Subject: Continued Section 106 Consultation for the Department of Veterans Affairs San Francisco Medical Center: Construction of Building 23 (Mental Health Research Annex, LRDP Sub-phase 1.13

Project Title
SAN FRANCISCO VA MEDICAL CENTER
NEW MENTAL HEALTH RESEARCH ANNEX

Re: Response to 662/138 Section 106 Consultation for the Department of Veterans Affairs San Francisco Medical Center: Construction of Building 23 (Mental Health Research Annex, Sub-phase 1.13)

3 EXTERIOR ELEVATION - EAST
1/8" = 1'-0"

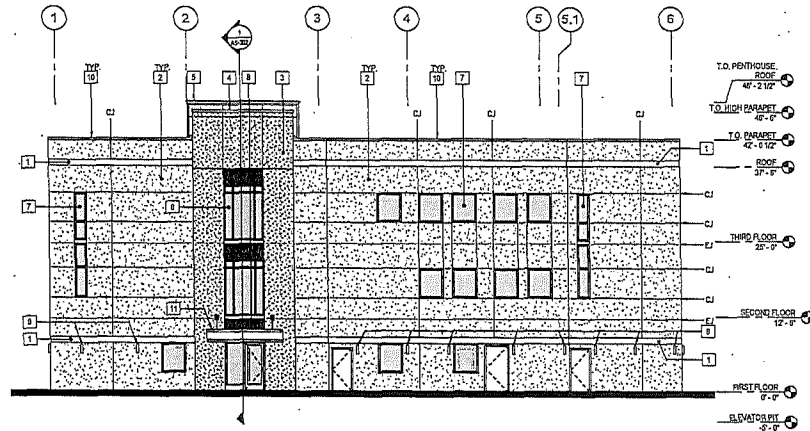
The east façade faces a wooded boundary line and the FMMR Historic District. The façade features five groupings of three or four anodized aluminum-frame windows at each story. Like the north and south boundaries, each window grouping is recessed within a vertical bay. The north, east, and west façades do not contain any doors.

During the design development process, representatives from SFVAHCS solicited input from GGNRA on the proposed design of Building 23 and its potential impact on the FMMR Historic District. As a result of this coordination, increased attention has been paid to treatments at the rear of the building, which faces the SFVAHCS's shared boundary with the FMMR Historic District. The proposed fenestration at this façade features extensive glazing, thus avoiding a blank or minimally decorated wall facing the FMMR Historic District. Mechanical equipment will not be located at the rear of the building, but rather will be placed on the roof in order to lessen its visibility.

When designs are further developed, we hope to see a design treatment consistent with that of the adjacent Building 24, such as a similar cladding, vertical inset window treatment with opaque spandrel panels, window frames and glazing that allow minimal night light into the park, and rooftop mechanical equipment shielded from view by a parapet and buffered against sound bleed.

4 EXTERIOR ELEVATION - WEST
1/8" = 1'-0"

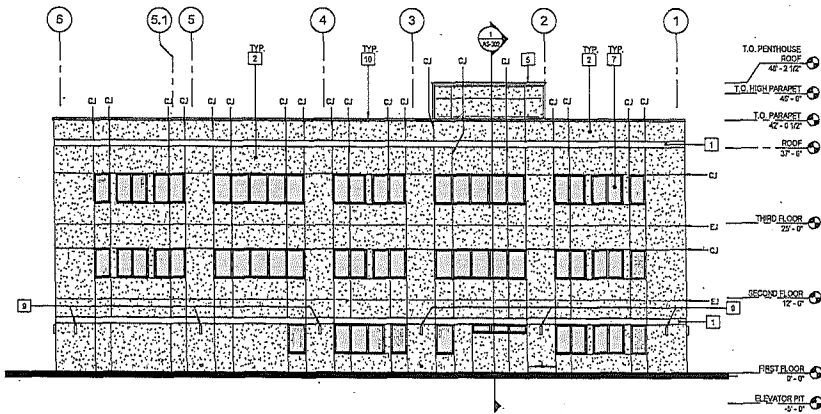
The primary façade of Building 23 faces west onto the campus core/historic district of SFVAHCS. The façade is designed to accommodate two factors: the viewshed/access to the site from Veterans Drive, and the irregularly shaped parcel. The building is partially visible via a corridor between Buildings 8 and 9 from Veterans Drive. The primary entrance is located at the center of the view corridor. The entrance is articulated by a protruding full height bay. The bay features the primary entrance at the ground level comprised of paired glazed doors under a flat canopy, and a two-story bank of windows above the doors. The entry bay features a three-sided parapet that rises above the parapet of the main building to 46'-6".

The shape of the parcel is irregular, with the southern end being narrower than the north end. Therefore, the west façade of Building 23 was designed with two full-height set-backs, moving from north to south (left to right). The west façade also features additional doors at the first floor, and punched anodized aluminum-frame windows at the second and third stories.

The impact to the location has been minimized by adapting some of the characteristics of the historic buildings to Building 23, such as the flat roof, parapet, and punched windows on the west façade. Per guidance about Fenestration Patterns on page 41 of the Design Guidelines, efforts were made to create the impression of vertical fenestration on the north, south, and east façades through recessed bays. The entrance bay was centered within the view corridor from Veterans Drive, and features a two-story bank of windows above the doors, further reinforcing the vertical nature of the building's fenestration.

Drawing Title
LANDSCAPE LAYOUT AND MATERIALS PLAN AND DETAILS
Project Title
SAN FRANCISCO VA MEDICAL CENTER
NEW METAL HEALTH RESEARCH ANNEX
Location
4150 CLEMENT STREET, SAN FRANCISCO, CA 94131
Date
09/30/16
Checked
Drawn

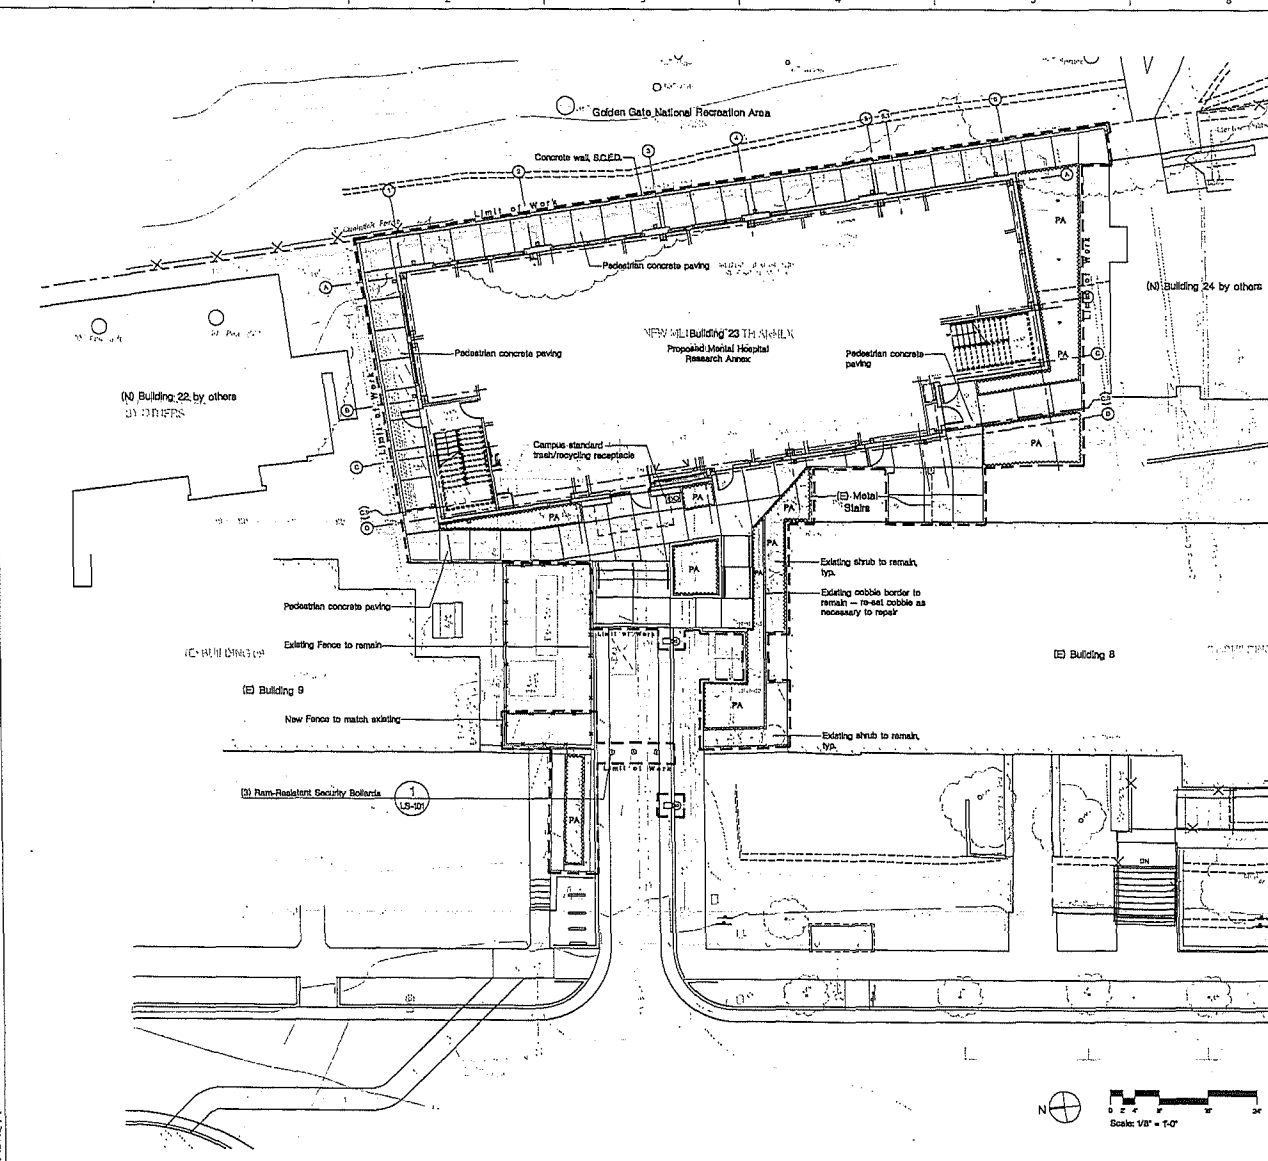
The NPS supports the idea of a sidewalk running between the east side of Building 23 and the boundary with the park. We ask that this sidewalk connect with the similar sidewalk planned for the east side of Building 24, and that the Building 23 sidewalk not preclude the possibility of a new park pedestrian entrance, possibly between Buildings 22 and 23. If the construction of Building 23 will include an extension of the new concrete retaining wall and fence proposed for the east side of Building 24, then

please provide the Park with architectural plans and illustrations that include a view of the fence from the adjacent NPS property, once designed. We ask that you avoid any excavation on Park property.
